Service Information No. 04 / 04

Pressure Switch in the Cooling Circuit

M 43 with GL Approval

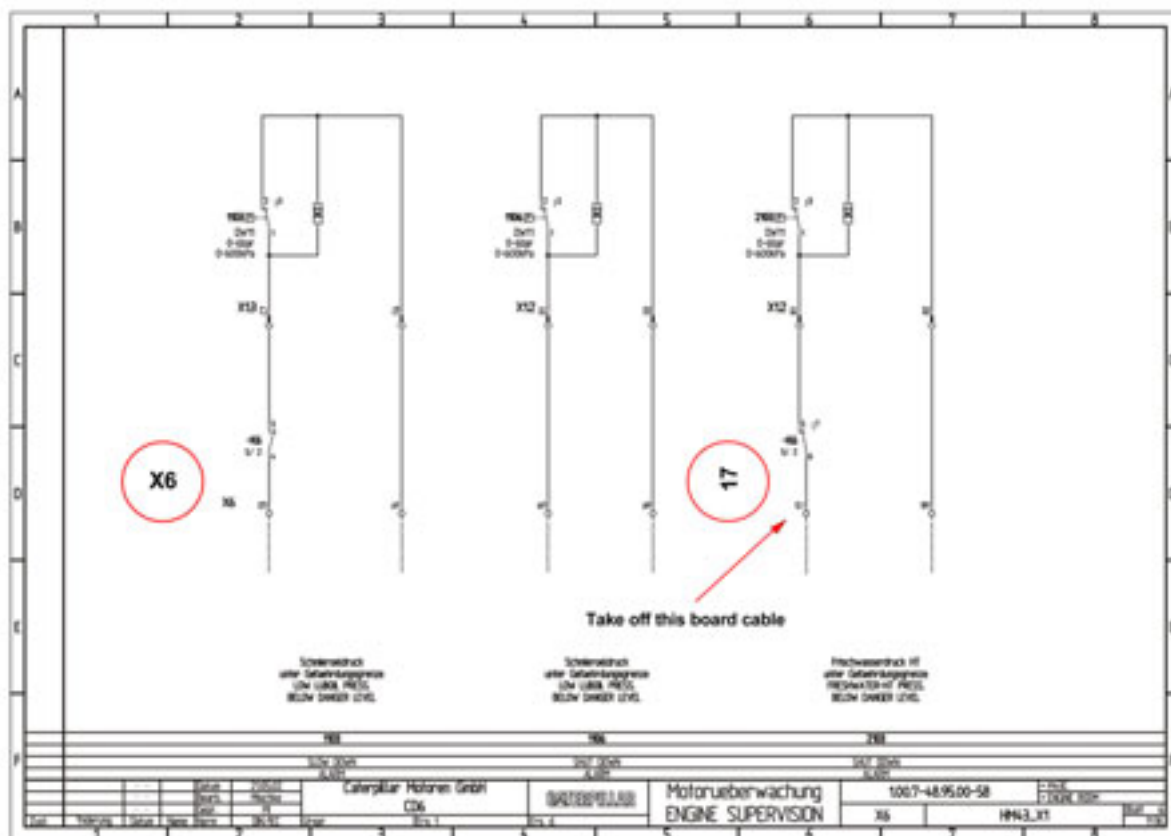
What has to be done:

At terminal strip X6 the board cable must be removed from terminal 17.

Fig. 2

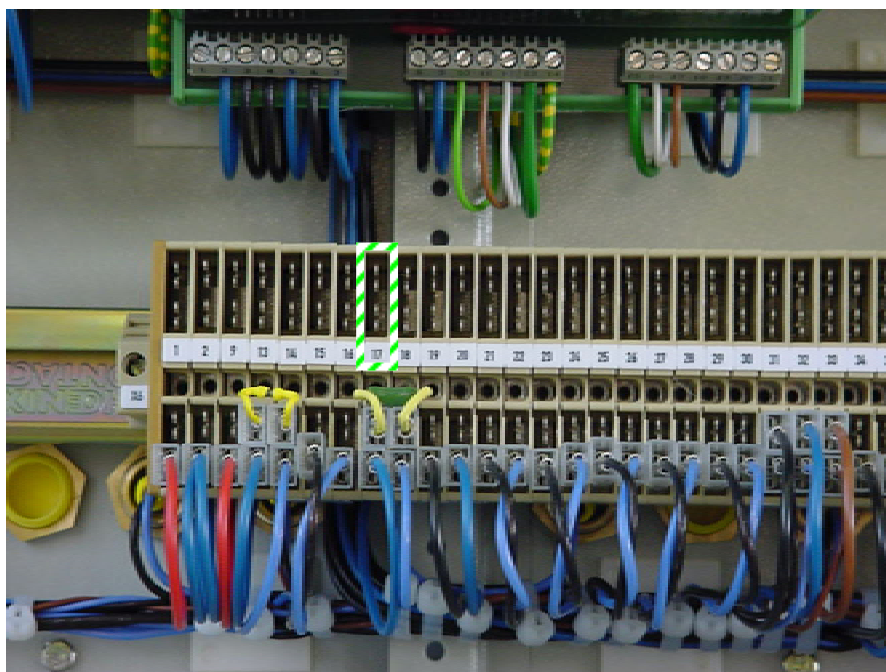
1. Open the switch box on the engine by means of the switch box key.
(located laterally on the engine at the exhaust side)
2. Look for terminal strip X6.
(the code X6 is to be found at left-hand side on the terminal strip, see Fig. 2)
3. Look for terminal 17 of this strip.
(highlighted in Fig.2)
4. Remove the board cable from this terminal 17.
(in Fig. 2 terminal 17 is already shown without board cable)
5. Completely insulate the removed cable end/cable plug with suitable insulating tape.
6. Fasten this free cable end in an appropriate way so that it cannot come into electrical or ground contact.
7. Close the switch box.
